**In the matter of**            Applications by **Fulton Hogan Limited** for all resource consents necessary to establish, operate, maintain and close an aggregate quarry (**Roydon Quarry**) between Curraghs, Dawsons, Maddisons and Jones Roads, Templeton

**REBUTTAL EVIDENCE OF ROGER STEVEN CUDMORE ON BEHALF OF FULTON HOGAN LIMITED**

**AIR QUALITY**

**DATED: 21 OCTOBER 2019**

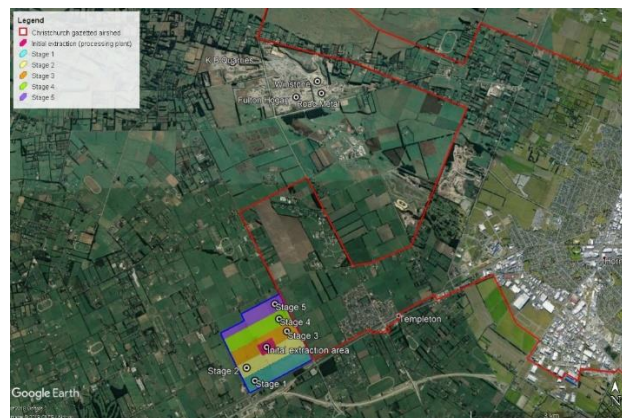
22. In this instance the western extent of the gazetted airshed boundary has nothing to do with problematic ambient PM10 levels. This is highlighted by the following figure, which shows the boundary as a redline. From this it is clear that application of Regulation 17 in this instance, applies to rural land where people are not exposed for the relevant time frame and for which degraded urban air quality does not apply. This is not the purpose for which Regulation 17 was promulgated in my view. This means investigation of compliance by Fulton Hogan is necessary to address a technical issue but regardless, Fulton Hogan's discharges of PM10 are not very likely to cause, or exacerbate adverse effects that are related to elevated ambient PM10 during cold still days within polluted areas of Christchurch City's urban air shed.
